MEMO

SUBJECT: Proposed Draft N/NE Quadrant Plan - Response to PSC Questions (pg.1) and Proposed Amendments (pg.8)

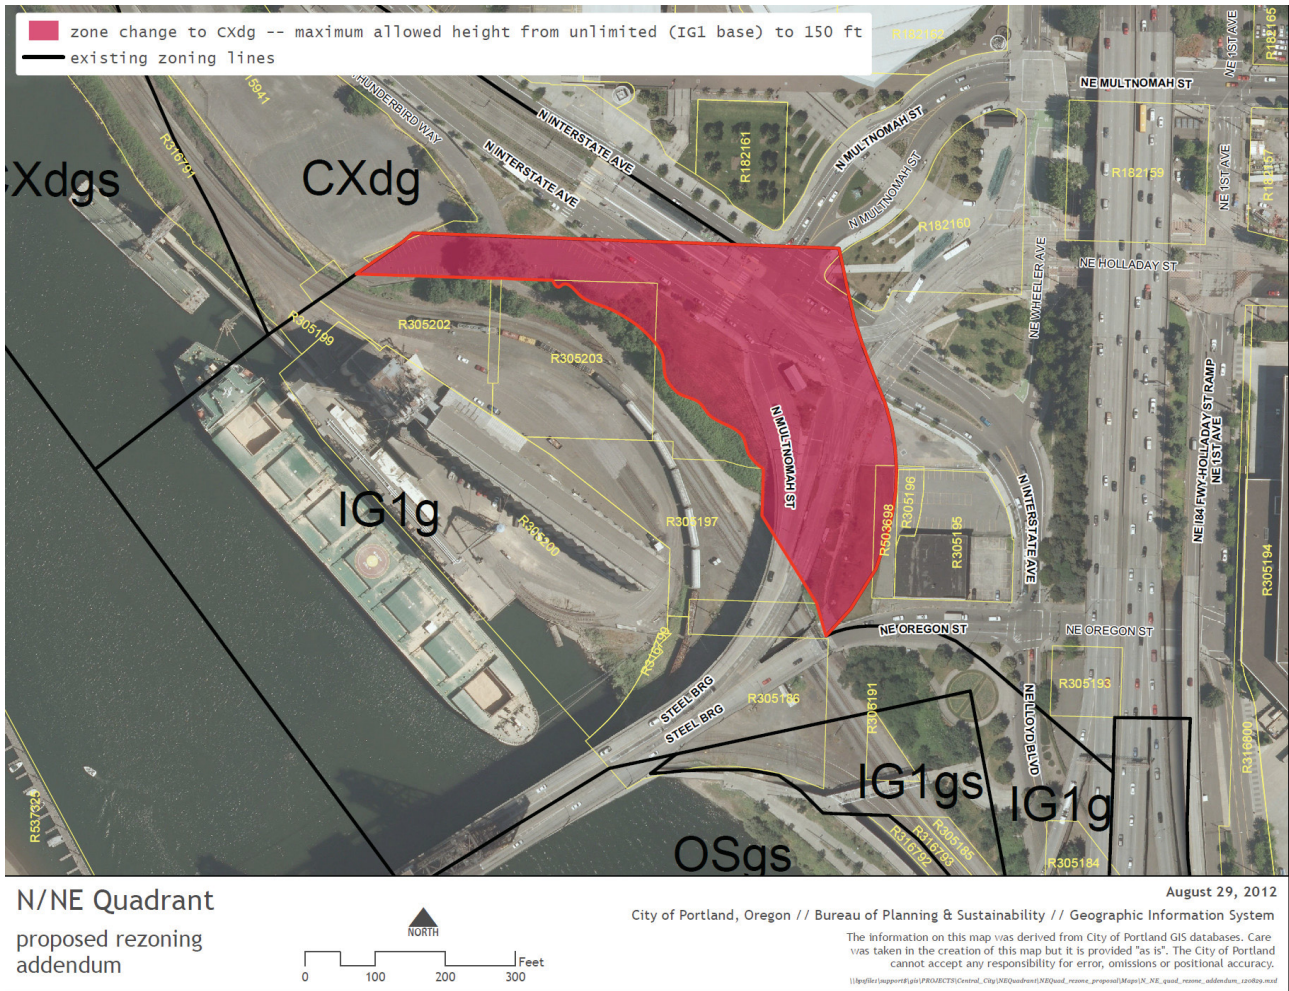
TR14, Work with TriMet to improve the Street Bridgehead and Rose Quarter Transit Center. Add the following text and map:

“In order to facilitate future reconfiguration of street and lot patterns near the transit center and improve the area’s development potential, the plan recommends rezoning 3.3 acres of land west of the transit center from General Industrial 1 (IG1g) to Central Commercial (CXdg), as shown on the map below. The existing River General (g) overlay zone would remain. Approximately 93 percent of the area is in public rights-of-way. Most of the area is not currently developable but some of the land west of North Interstate could potentially be used for small or interim uses prior to a major reconfiguration of the area. Central Commercial zoning with the Design (d) overlay that matches the surrounding zoning will facilitate future development that takes advantage of regional transit access and supports the plan’s vision of a highly urban and vital Lloyd District.”
